1. Minutes February 19, 2020 Regular Meeting. (March, April, and May meetings were canceled.)
- D. Action Items**
- 5:45 2. Certificate of Appropriateness Application**
BAR 20-03-01 (previously noted as BAR 19-09-03)
503 Rugby Road
Tax Parcel 050052000
Epsilon Sigma House Corps of Kappa Kappa Gamma, Owner
Erin Hannegan (Mitchell Matthews Architects), Applicant
Building renovations – revisions to approved design

ATTACHMENT A: FEBRUARY 19, 2020 BAR MEETING MINUTES

**BAR MINUTES
CITY OF CHARLOTTESVILLE
BOARD OF ARCHITECTURAL REVIEW
Regular Meeting
February 19, 2020 – 5:30 p.m.
City Council Chambers - City Hall**

- Mitchell Matthews Architects & Planners drawings 503 Rugby Road, Kapp Kappa Gamma Sorority, Board of Architectural Review: CoA Submission Amendment, dated February 25, 2020: Cover and sheets 2 through 37.

FRONT EAST ELEVATION (TOP) & SIDE SOUTH ELEVATION (BOTTOM)

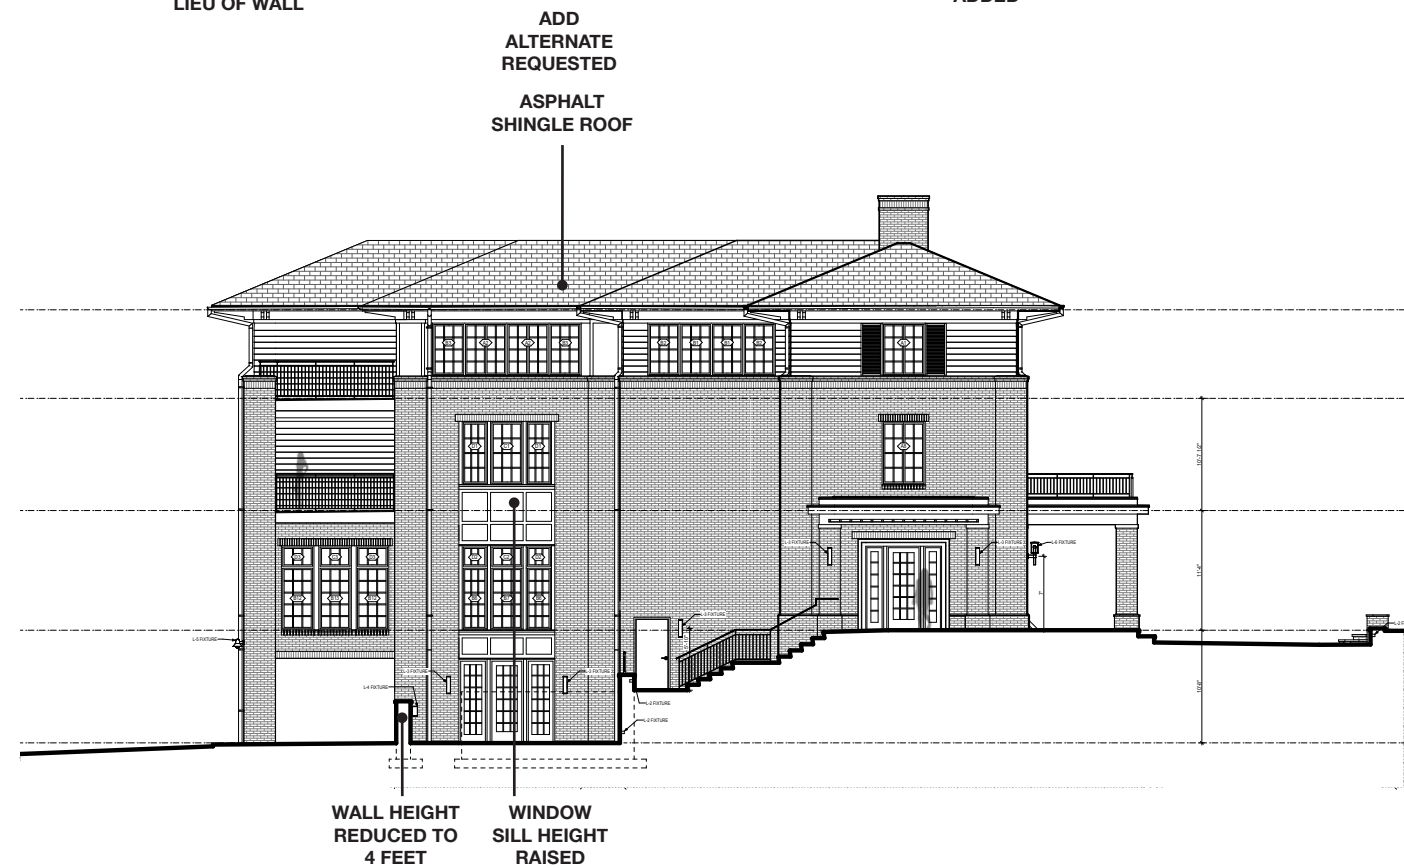
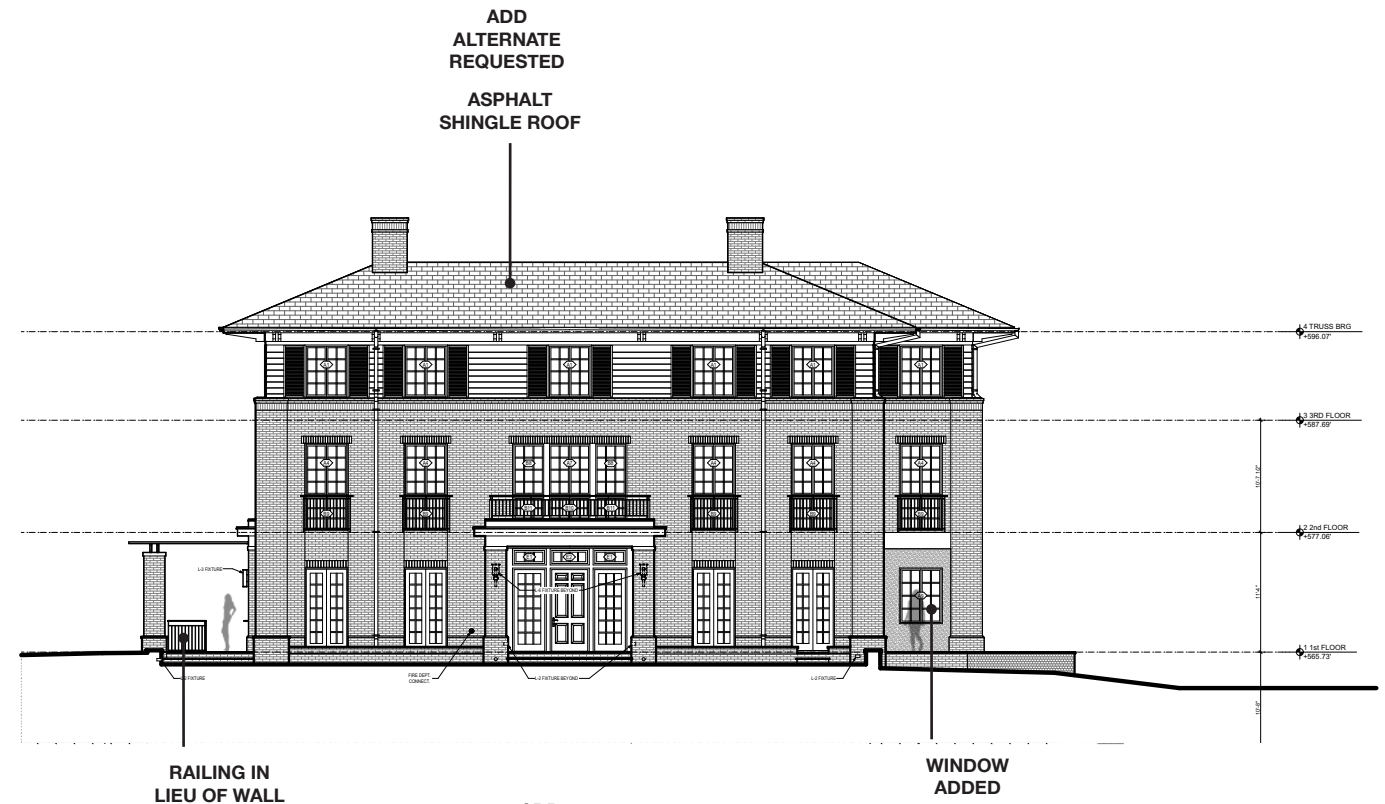
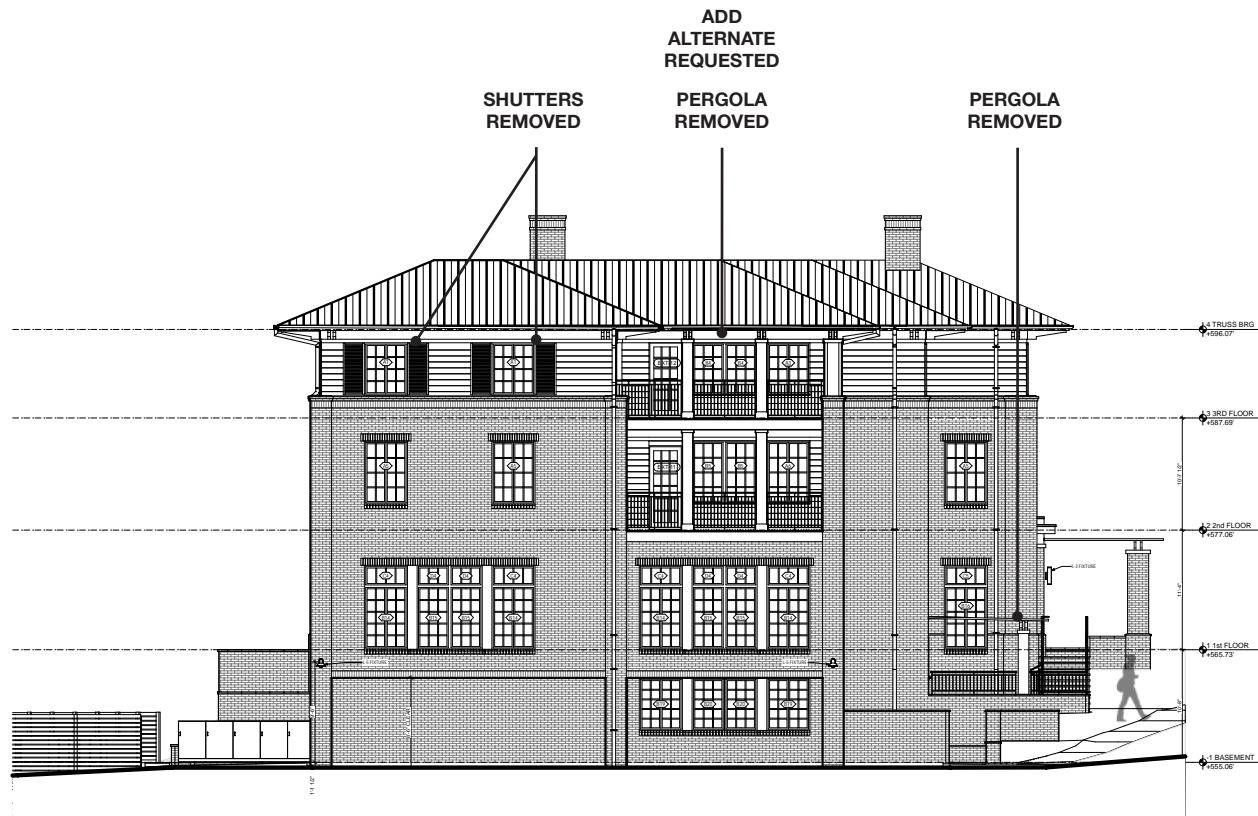
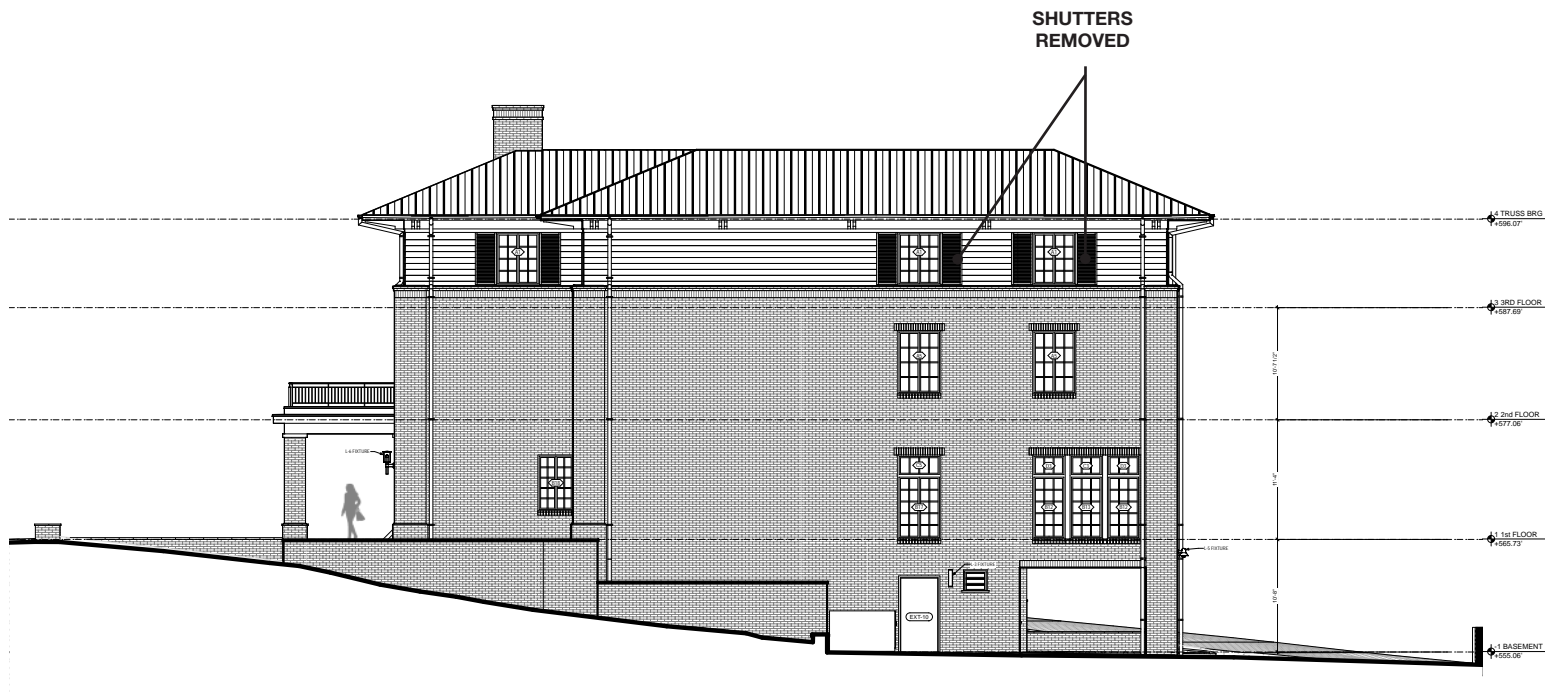
- Modify South facing window wall to raise sill of windows at 2nd floor lounge.
 - Staff: No issues. Matches sill height of other 2nd floor windows.
- Substitute asphalt shingles for standing seam metal roof. Proposed as an add alternate to revert back.*
 - Staff: Design Guidelines discourage, but do not prohibit. Proposed shingles are dark, somewhat textured, and consistent with the Design Guidelines.
- Add window at House Director unit entry porch on front East elevation.
 - Staff: Appropriate; adds an opening to an otherwise blank wall.
- Add mechanical louver, required for ventilation, under overhang at rear West elevation.
 - Staff: No issues.
- [Not noted on Page 2 of submittal.] At Parlor terrace, replace low wall with railing.
 - Staff: No issues.

- 12** Modify South facing window wall to raise sill of windows at 2nd floor lounge. See page 13.
- 13** Substitute asphalt shingles for standing seam metal roof. Proposed as an add alternate to revert back. See page 24.

SIDE (NORTH) ELEVATION (TOP)
REAR (WEST) ELEVATION (BOTTOM)

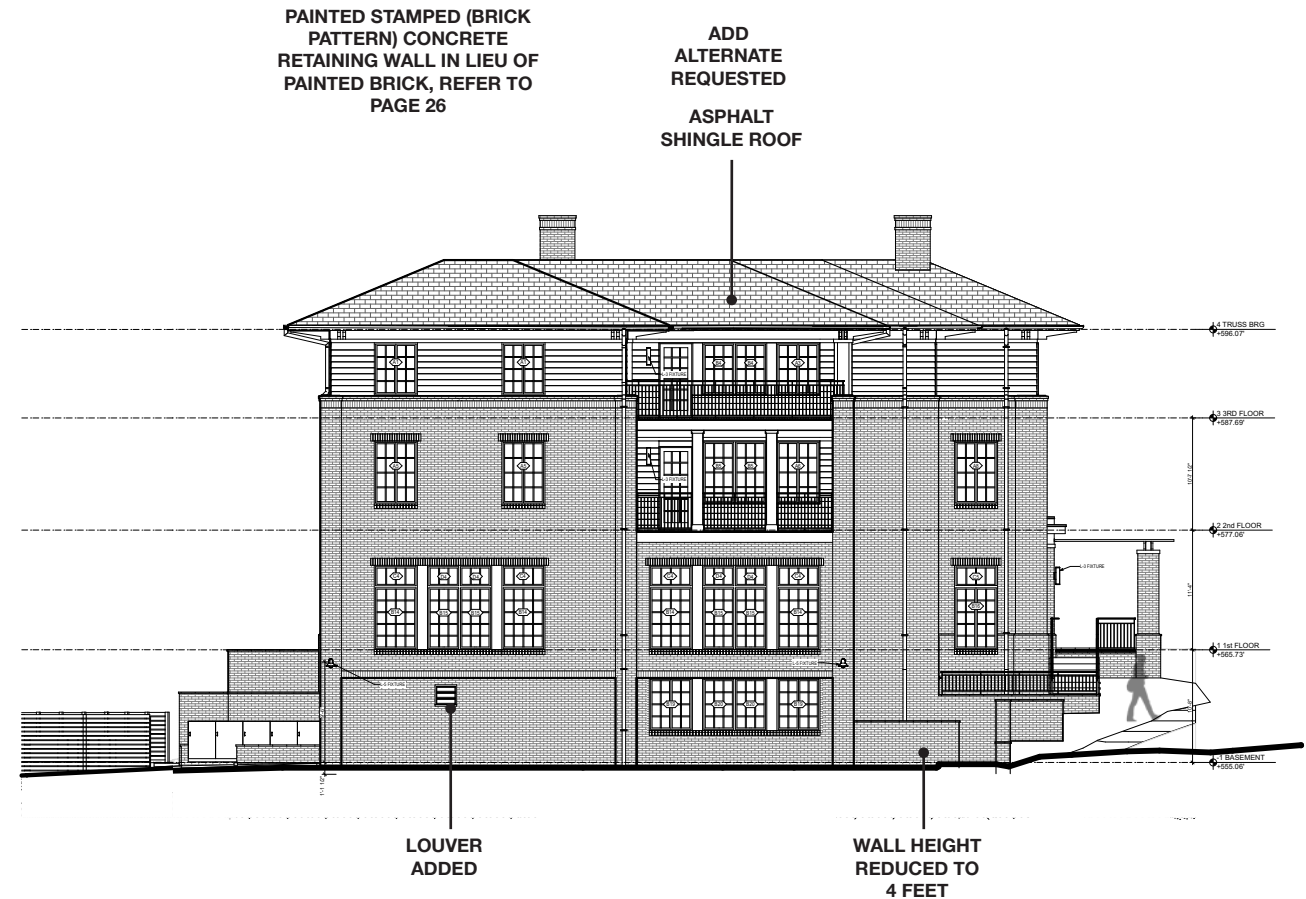
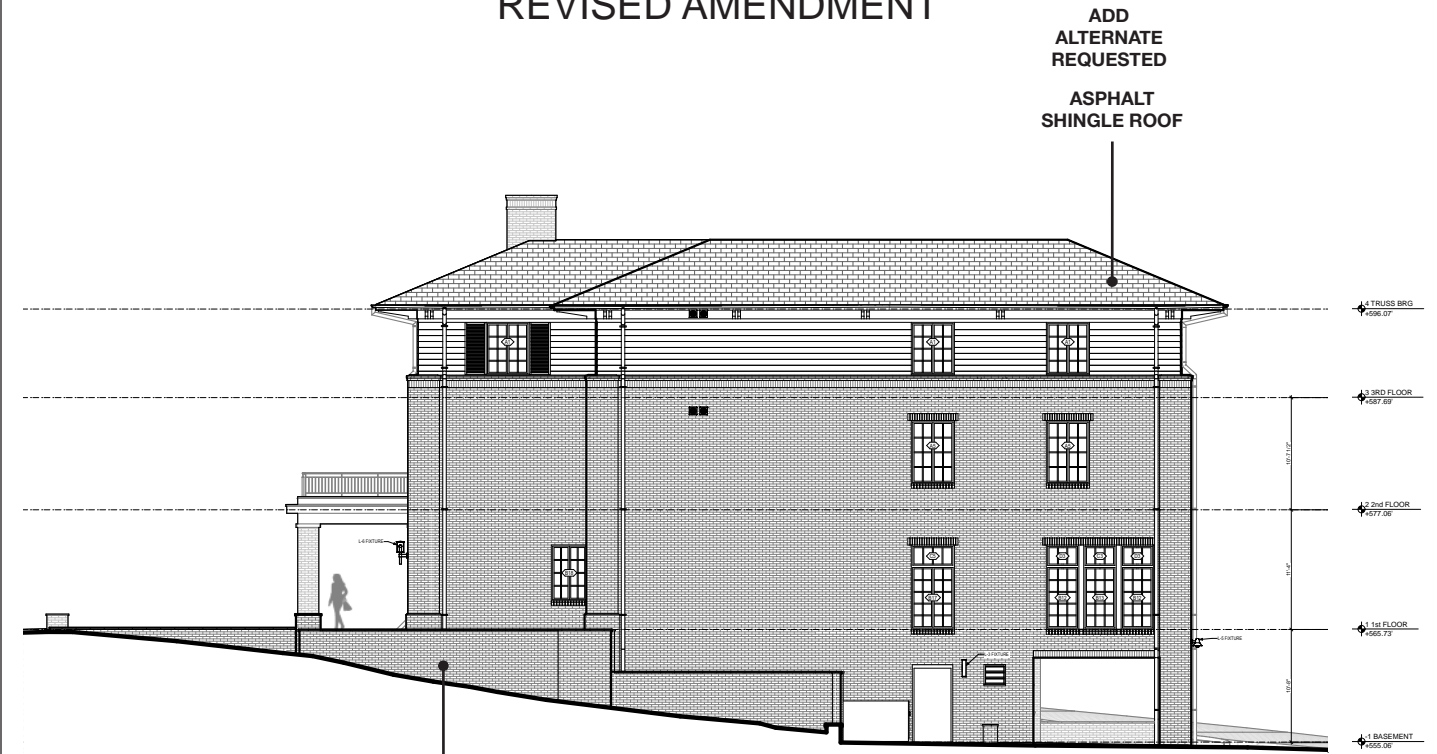
- Staff: No issues.
- Delete (2) sets of shutters from West elevation (back of building).
 - Staff: BAR should discuss. (See Design Guidelines for *Details & Decoration*.)

- Delete (2) sets of shutters from North elevation (side of building).
 - Staff: BAR should discuss. (See Design Guidelines for *Details & Decoration*.)

- 10** Delete (2) sets of shutters from West elevation (back of building). See page 15.
- 11** Delete (2) sets of shutters from North elevation (side of building). See page 14.
